[Docket No. 2001-NE-03-AD; Amendment 39-12097; AD 2001-02-12]

Airworthiness Directives; CFM International (CFMI) Model CFM56-7B Turbofan Engines

SUMMARY: This amendment adopts a new airworthiness directive (AD) that is applicable to CFMI model CFM56-7B turbofan engines. This action requires a one-time on-wing torque inspection, and torque if needed, of all the PS3 pressure line fittings to insure proper torque. This amendment is prompted by service events which resulted in two in-flight shutdowns (IFSD's) and an aborted takeoff due to the disconnection of one of the PS3 line fittings. The actions specified in this AD are intended to prevent air leakage from incorrectly torqued fittings of the PS3 line, which could result in engine power loss.

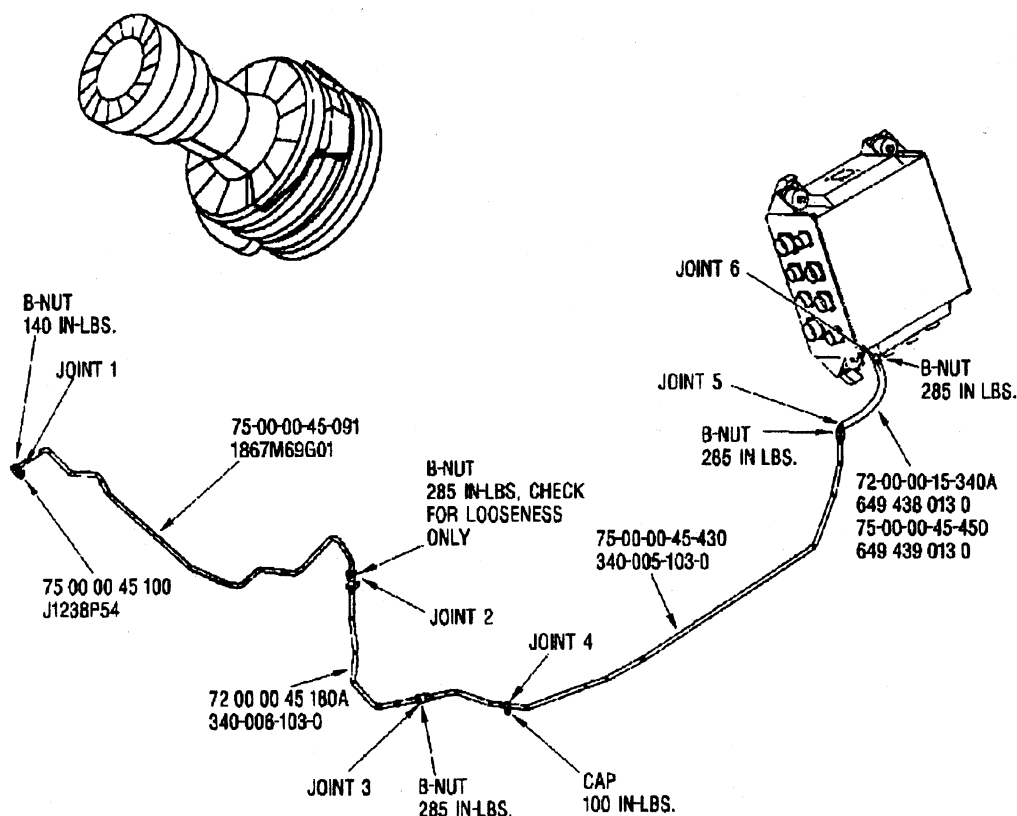
(a) Check for and apply the correct torque in the tightening direction of all PS3 pressure line fittings as identified in Figure 1 of this AD as Joint 1, Joint 2, Joint 3, Joint 4, Joint 5, and Joint 6 as follows:

(1) Torque Joint 1 to ensure a torque value of 140 inch-pounds.

(2) Due to accessibility limitations, check Joint 2 for finger looseness, and only if loose, torque to a value of 285 inch-pounds.

(3) Torque Joint 3, Joint 5, and Joint 6 to ensure a torque value of 285 inch-pounds.

(4) Torque Joint 4 to ensure a torque value of 100 inch-pounds.
